PHED COMMITTEE #2  
July 7, 2009

TO: Planning, Housing, and Economic Development Committee  
FROM: Glenn Orlin, <sup>Go</sup>Deputy Council Staff Director  
SUBJECT: Germantown Employment Area Sector Plan—transportation elements, follow-up

# West End Proposed Street Network

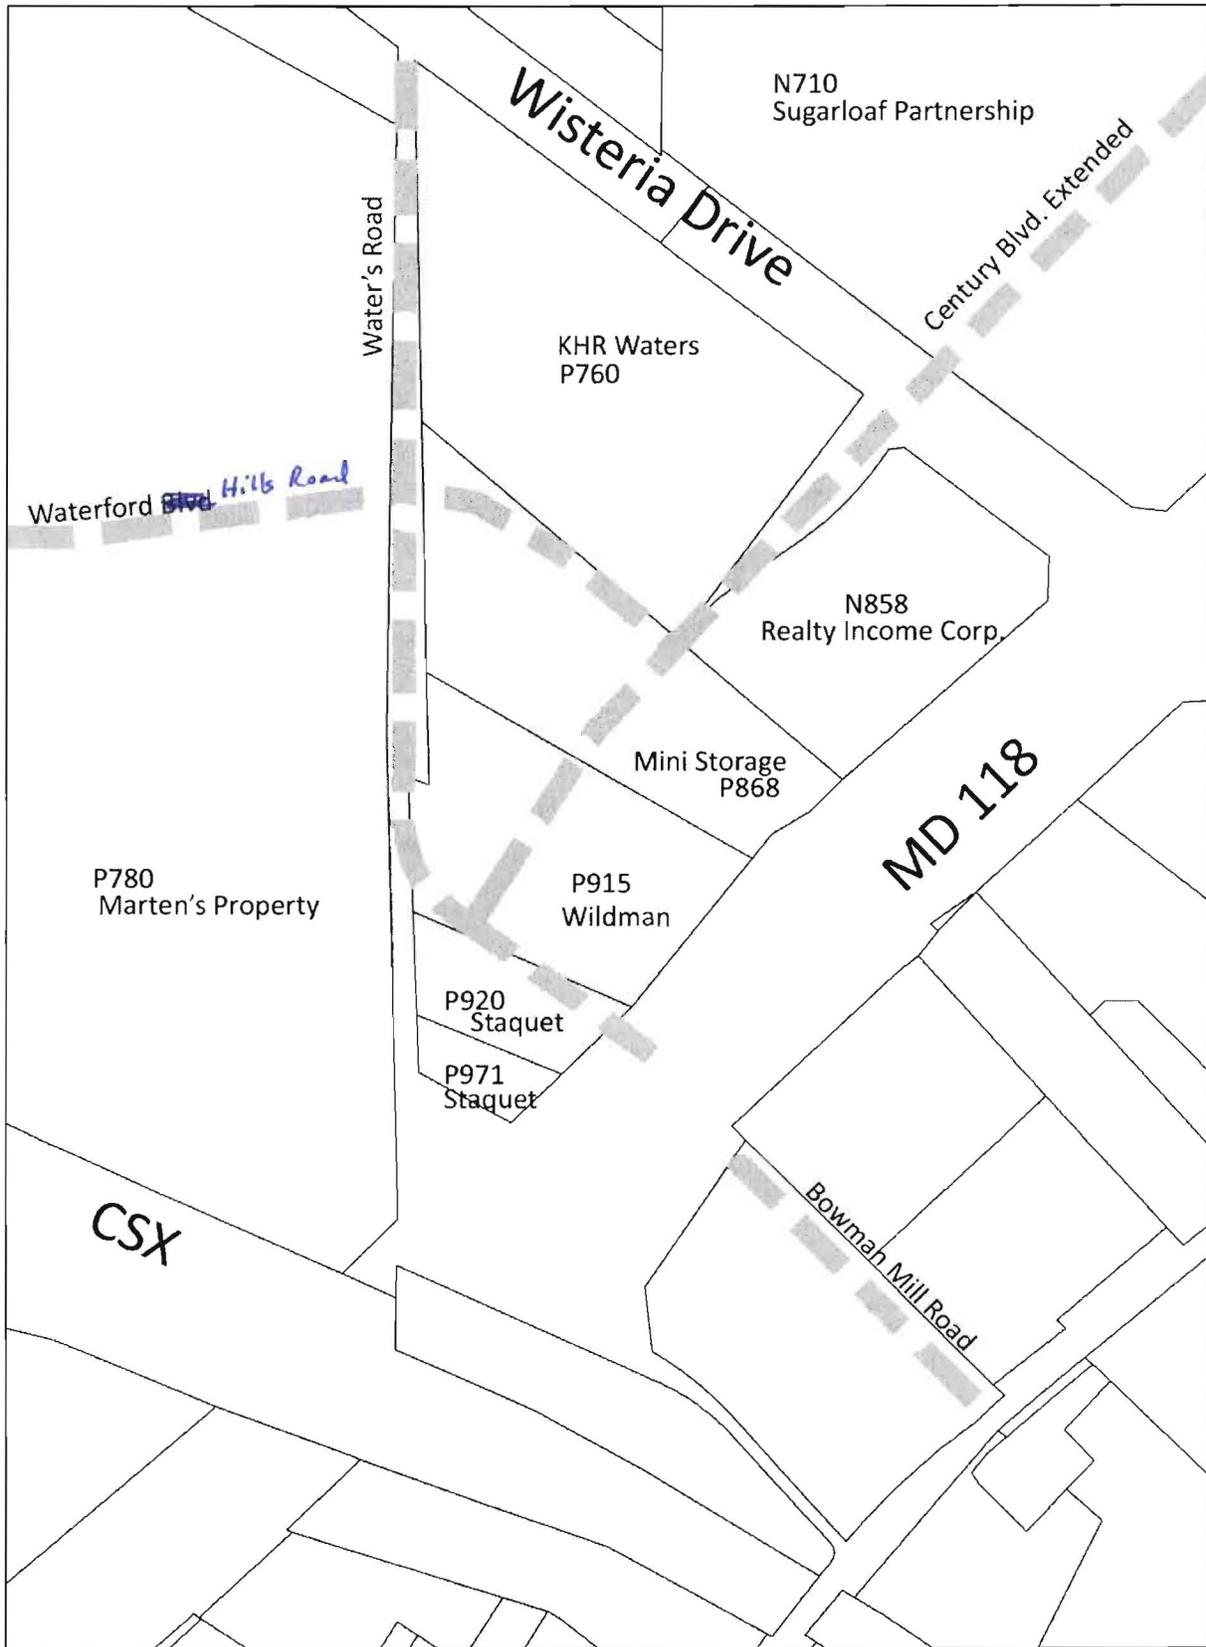
**3. West End street network.** The graphic on ©3 illustrates the street network for this portion of the Town Center/West End. The graphic shows the proposed centerline of new roadways and the properties affected by these roadways. The roadways include:

The Sugarloaf Partnership property is proposed for significant redevelopment which will provide the possibility to align Century Boulevard Extended on the west side of Wisteria Drive. The Wildman property (P915) and the Mini Storage property to the north (P868) would be split by the extension of Century Boulevard southwest of Waterford Hills Road. Jody Kline, representing Mark Wildman, recommended that the West End street network be revised so as not to severely impact Mr. Wildman's property.

**Council staff recommends eliminating the southernmost extension of Century Boulevard between Waterford Hills Road and Waters Road that bisects the Wildman and Mini Storage properties.** The West End will have sufficient circulation without this extension. Other Business District Streets may be developed as part of preliminary or site plan. Deleting this link will not affect land use/transportation balance.

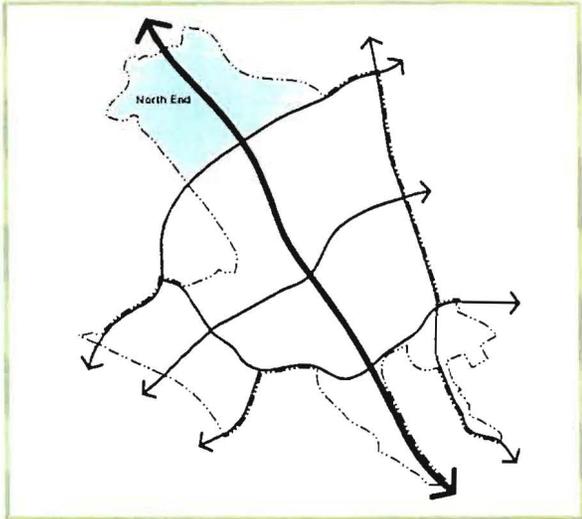
**4. Crystal Rock Drive alignment in North End District.** The Draft Sector Plan shows the north end of existing Crystal Rock Drive to be extended as a Business District Street (B-11) and looped around to meet Century Boulevard at the new Dorsey Mill Road, near the proposed Manekin CCT station. The Lerner Corporation, which owns much of the property through which this road would traverse, wishes to have the Sector Plan show B-11 not as a loop but as two roads intersecting at a traffic circle. (See the Rodgers Associates memorandum on ©4, Lerner's proposed development concept on ©5, and Draft Sector Plan's loop geometry is on ©6-7.)

**Council staff recommendation: Retain the current diagrams in the plan.** Identifying the specific alignment on ©5 in the plan presupposes that that particular development concept will be approved. Before all is said and done, what if the Lerner Corporation decides to proceed with a somewhat different concept? What if it ultimately decides to sell its interest to another developer, which may have a different concept? Rather than locking in an alignment now, the alignment in the plan should be as generic as possible. However, should the Lerner Corporation ultimately proceed with the concept through plan approval, **it would help if the Council were to provide supportive legislative history by indicating for the minutes that the alignment on ©5 is consistent with the Sector Plan.**

The attached plans show the proposed realignment of Crystal Rock Drive and Century Boulevard (Exhibit A), and the introduction of a roundabout or 'T' intersection where they intersect, instead of the more suburban type of sweeping 'loop' geometry as indicated in the current Planning Board Draft (see exhibits B and C). These modifications should have been included in the Planning Board Draft of the Master Plan, as neither the Planning Board nor planning staff objected to this new geometry.

### Roadway Network

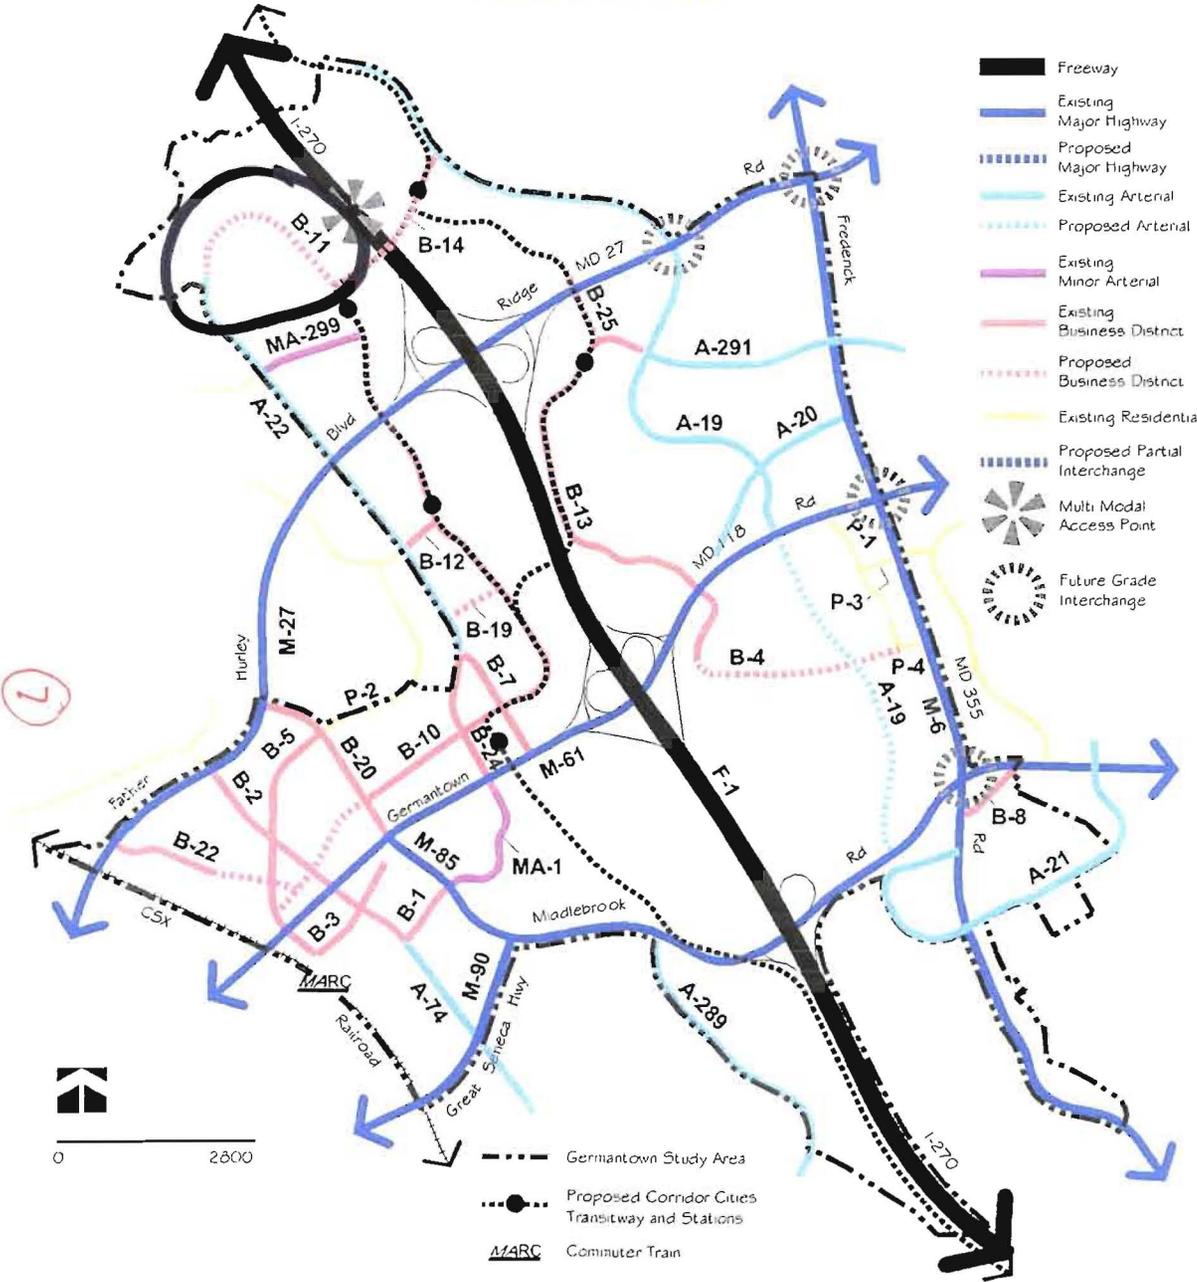
The Draft Sector Plan's diagrams merely mean that the end of Crystal Rock Drive and Century Boulevard should be connected by a Business District Street, thus what the Lerner Corporation is proposing is consistent with the Draft Sector Plan. It is common for a master plan to propose a connection, with the ultimate shape of that connection to be determined at preliminary plan or site plan approval. An example: the Kensington/Wheaton Master Plan

## Master Plan for the Communities of Kensington Wheaton Montgomery County, Maryland

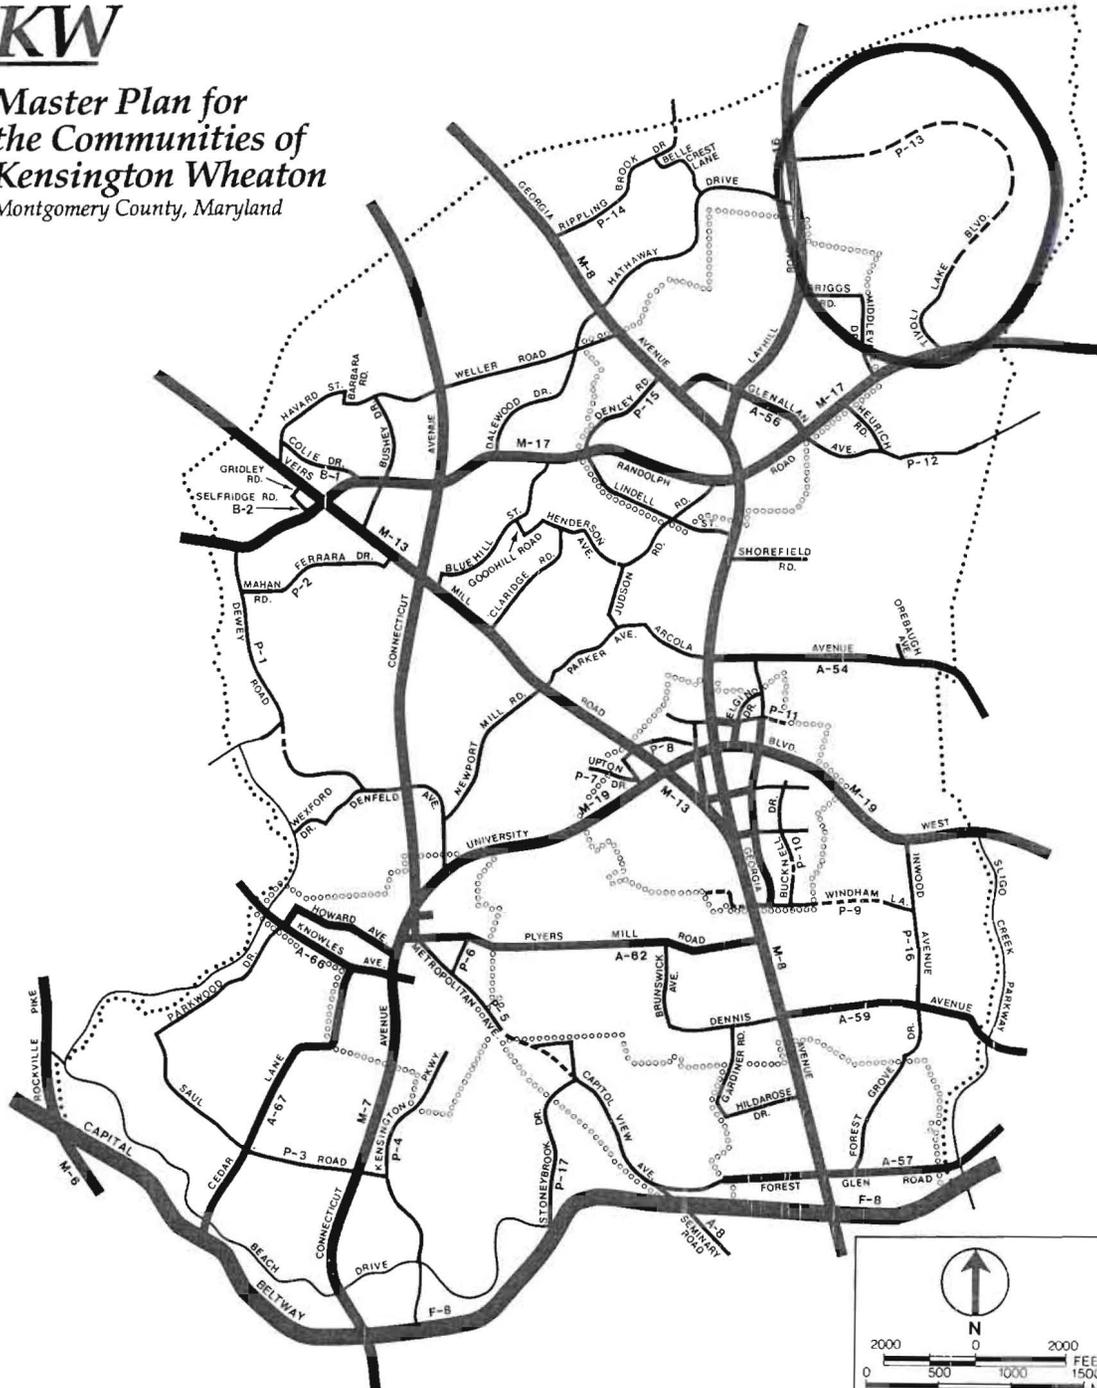
proposed a future primary residential street connection through the Indian Spring Country Club between Georgia Avenue and Layhill Road via Tivoli Lake Boulevard and the Indian Spring Access Road. The plan showed a looping alignment (see P-13 on ©8). However, when the preliminary plan was approved 18 years later, it showed that the extension of these two roads met at a town square (©9): the primary residential street connection was made, but at a town square requiring right-angled turns, not dissimilar to what the Lerner Corporation proposes.

134' RIGHT-OF-WAY  
CENTURY BOULEVARD  
EXHIBIT

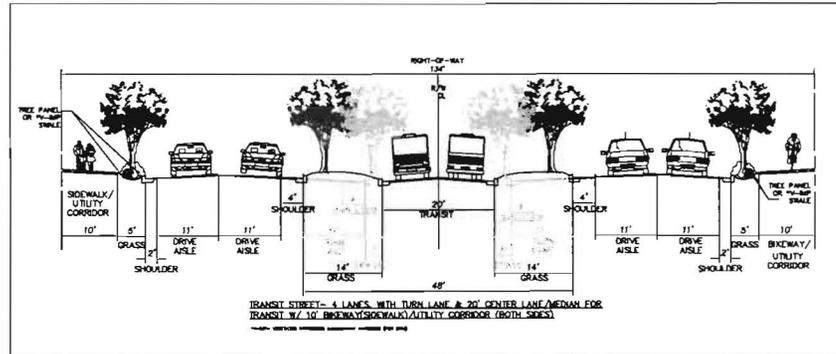
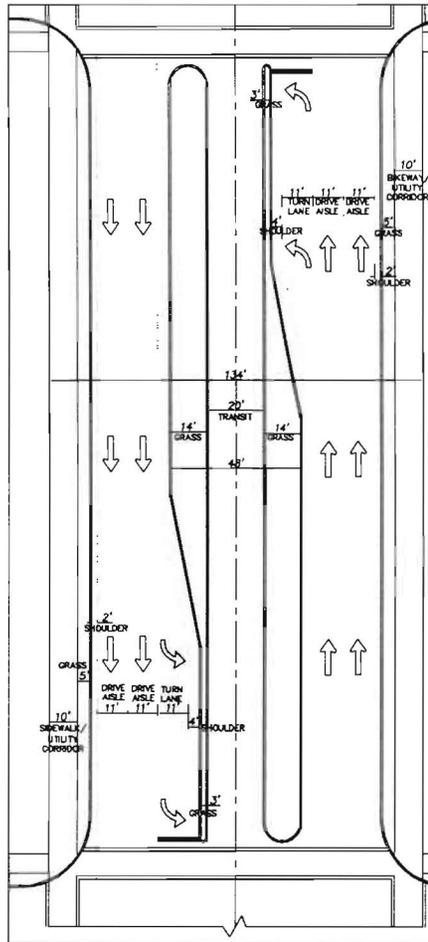
Robert Brewer, representing Trammel Crow, recommends a 134'-wide right-of-way for this section of Century Boulevard. He transmitted a typical plan view and cross-section showing how 134' could accommodate four travel lanes (each 11' wide) with a 4'-wide offset to the inside curb and a 2'-wide offset to the outside curb, 14'-wide planting strips between the CCT and the roadways and 5'-wide strips between the roadways and the sidewalk or bike path (©10).

**Council staff recommendation: Set the minimum right-of-way at 134'.** Council staff believes the curb offsets in ©10 are too generous (1' to either the inside or outside curb is sufficient, requiring 8' less) and that the CCT width is too narrow (it should be 6' more: 26', not 20'), and that the planting strip between the CCT and each roadway should be 15' not 14' (requiring 2' more). This would provide the 56' required by MTA within a 134' right-of-way. Also recall that rights-of-way designated in master and sector plans are *minimums*: the Planning Board can require a wider right-of-way in spots where ancillary facilities are necessary: turning lanes, stormwater management facilities, etc.
